**CITY OF FREDERICKSBURG
HISTORIC REVIEW BOARD**

AGENDA

Tuesday, January 9, 2018

CERTIFICATE OF APPROPRIATENESS APPLICATIONS

Date:
12-27-17

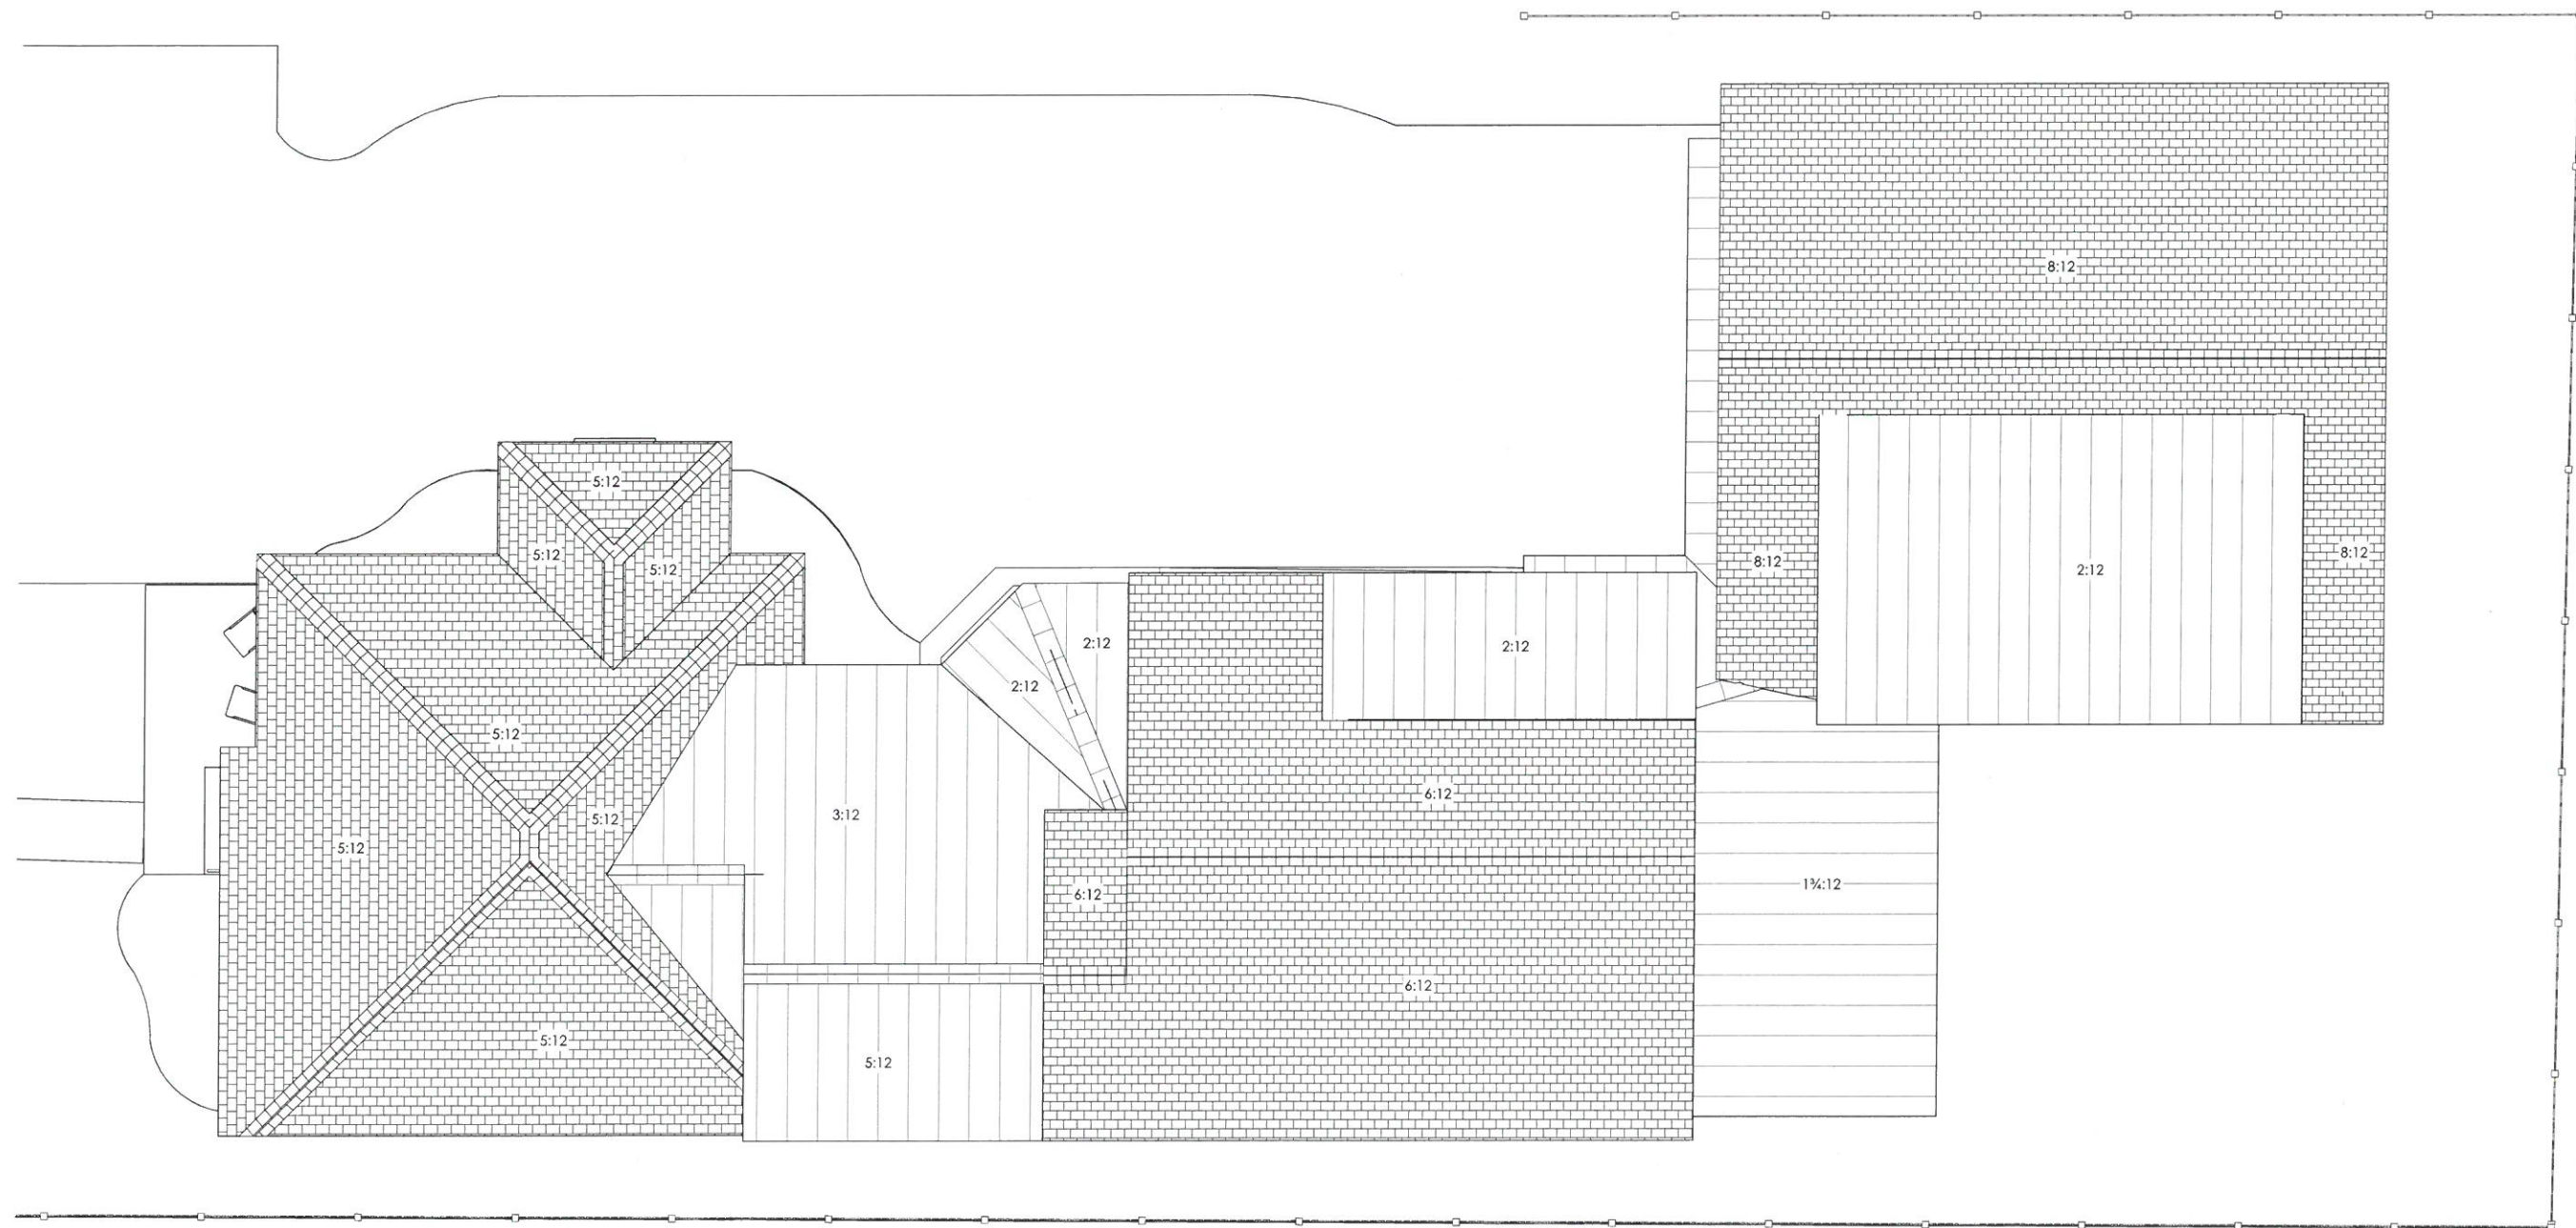
1. The proposed addition is appropriate in material and style, however the massing and scale overwhelm the small cottage. The applicant has tried to minimize the mass by using a one story connector, but new addition dominates the site. Staff does not recommend approval based on FBG Design Guidelines for new additions and new construction.
2. Staff recommends approval of the alterations to the existing house. The paint color is appropriate and the proposed bracket is a minimal design change to extend the life roof.
